Index 715-002 Standard Aluminum Lighting

COMMENTARY

COMMENTS AND RESPONSES

INDEX 715-002	SHEET 2 of 8
------------------	-----------------

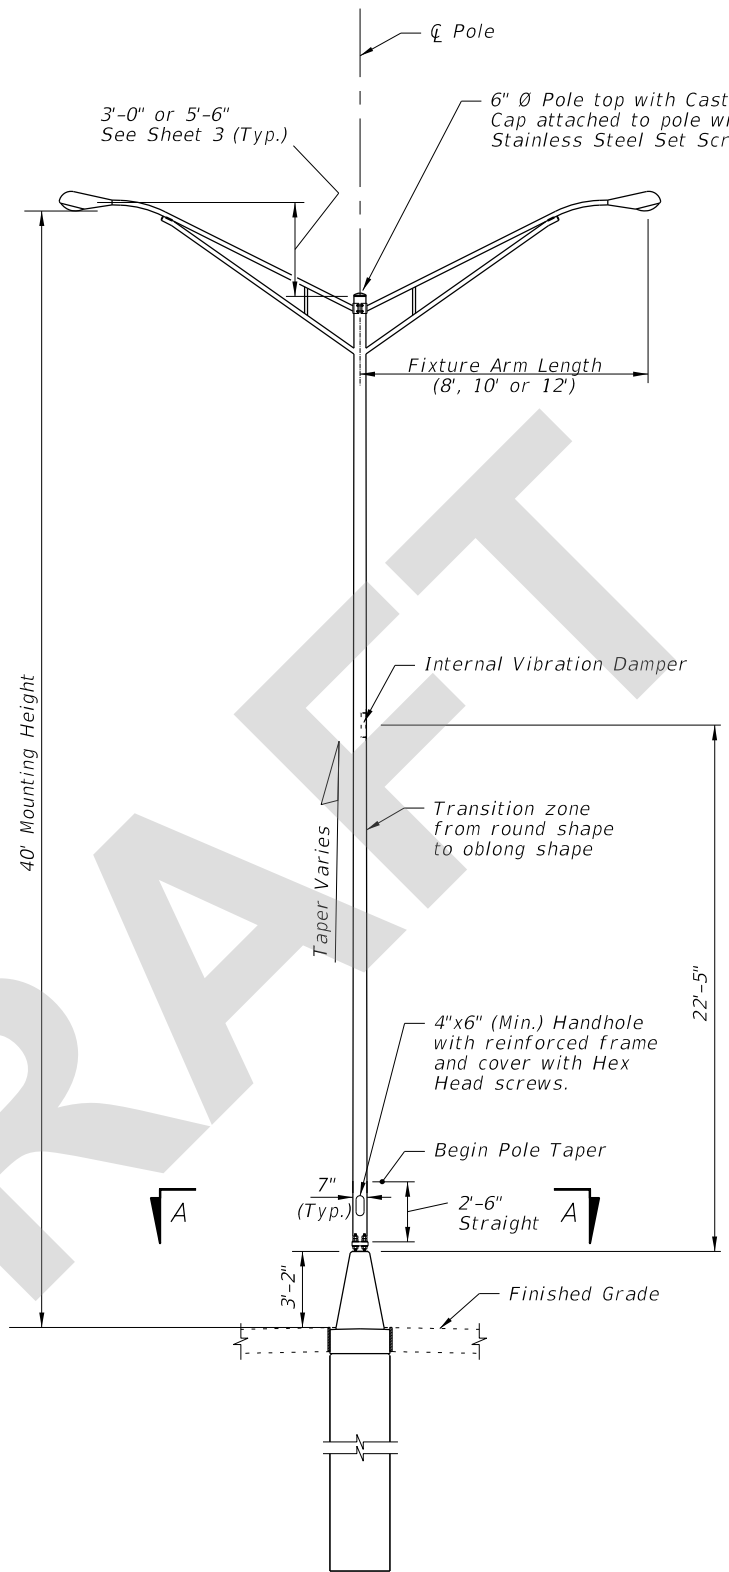
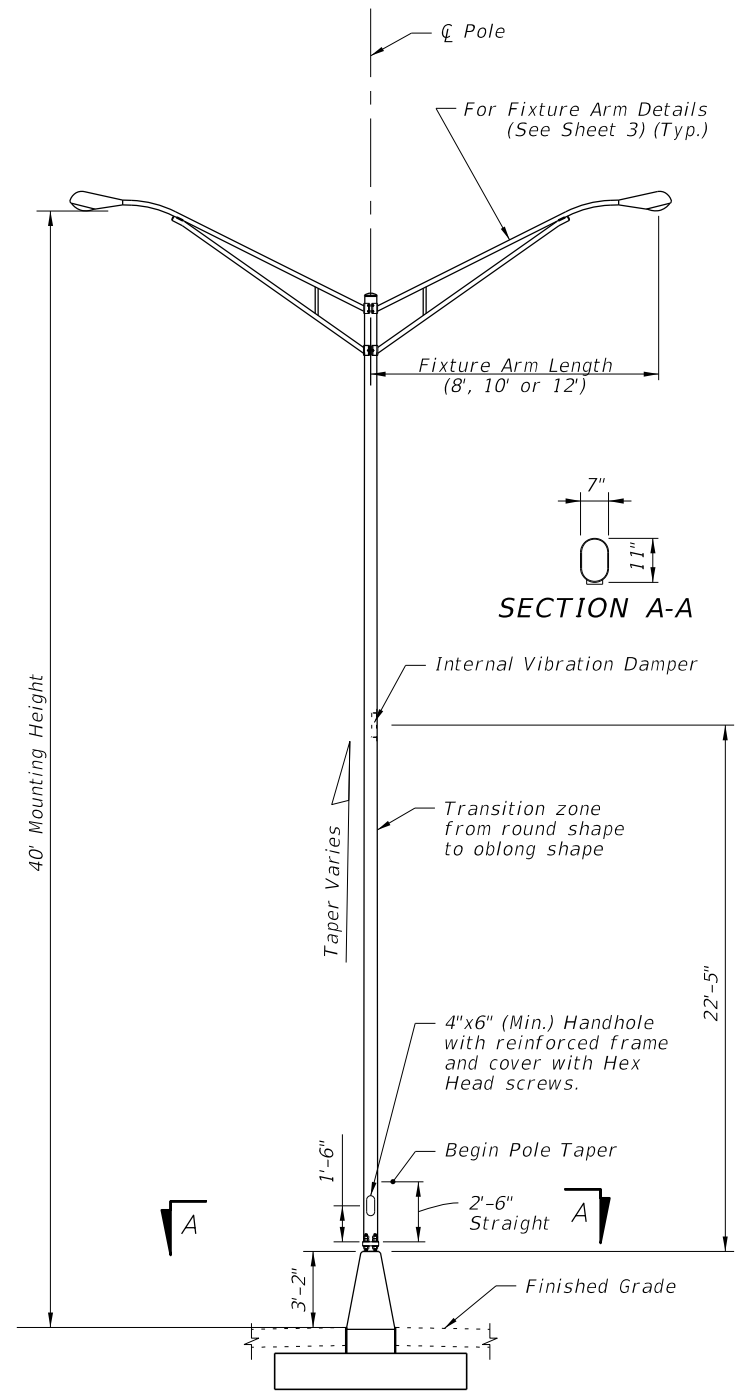
COMMENT: Sheet 2: Wildlife-sensitive mounting heights. The FWC and lighting designers believe FDOT requires wildlife-sensitive lights can only be placed at 20 or 25 feet. This causes difficulty with lighting design and meeting requirements for uniformity ratios. Please clarify if wildlife-sensitive lights can be mounted at standard heights too (30 feet and higher).

RESPONSE: This is beyond scope of original revision, but clarification is a small change and can be made.

Change made to Index: Sheet 2: Added clarification to callout. Wildlife-Sensitive lighting may also be used with standard mounting heights 30 feet through 50 feet (original intent).
